Page 1  
FORM  
4  
Rev 12/05State of Colorado  
Oil and Gas Conservation Commission

## SUNDRY NOTICE

<input type="checkbox"/> Notice of Intent		<input type="checkbox"/> Report of Work Done	
Approximate Start Date:		Date Work Completed:	
Details of work must be described in full on Technical Information Page (Page 2 must be submitted.)			
<input type="checkbox"/> Intent to Recomplete (submit form 2)	<input type="checkbox"/> Request to Vent or Flare	<input type="checkbox"/> E&P Waste Disposal	
<input type="checkbox"/> Change Drilling Plans	<input type="checkbox"/> Repair Well	<input type="checkbox"/> Beneficial Reuse of E&P Waste	
<input type="checkbox"/> Gross Interval Changed?	<input type="checkbox"/> Rule 502 variance requested	<input type="checkbox"/> Status Update/Change of Remediation Plans	
<input type="checkbox"/> Casing/Cementing Program Change	<input checked="" type="checkbox"/> Other: Relief from RSAP COAs	for Spills and Releases

1. OGCC Operator Number: 100185 API Number: 05045212900000  
 2. Name of Operator: Encana Oil & Gas (USA) Inc. OGCC Facility ID #  
 3. Well/Facility Name: Federal Well/Facility Number: 21-9D (PJ21)  
 4. Location (QtrQtr, Sec, Twp, Rng, Merid

## Encana Federal 21-9D (PJ21) 045-21290

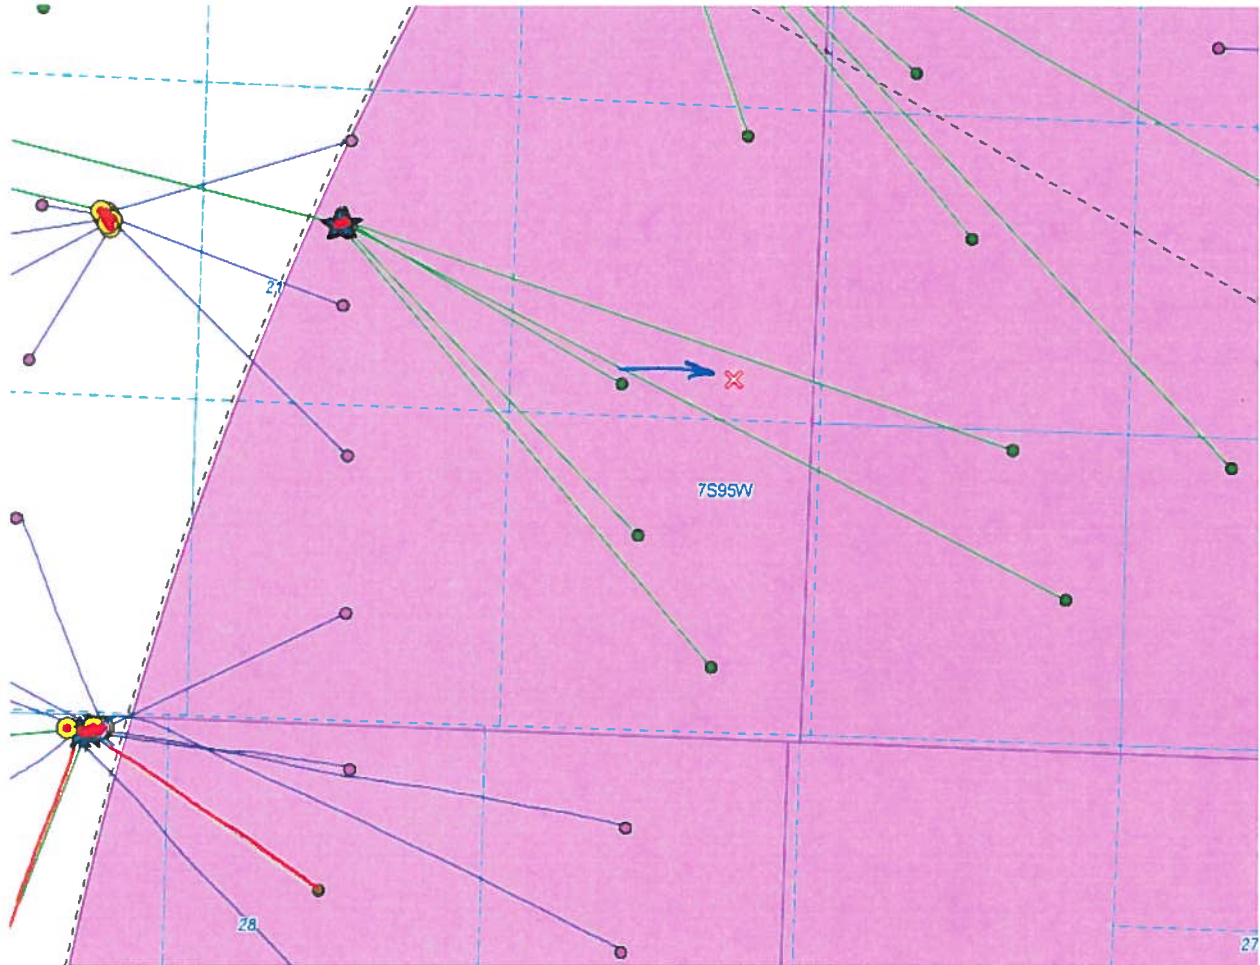
- Section 21 7S 95W
- BHL revised via sundry notice:
  - BHL footages on scout card are correct
  - TPZ footages on scout card should be the same as BHL - need to be updated
  - BHL on map needs to be updated – moved to red "X" = new proposed Bit L.  
ATE 1/31/13
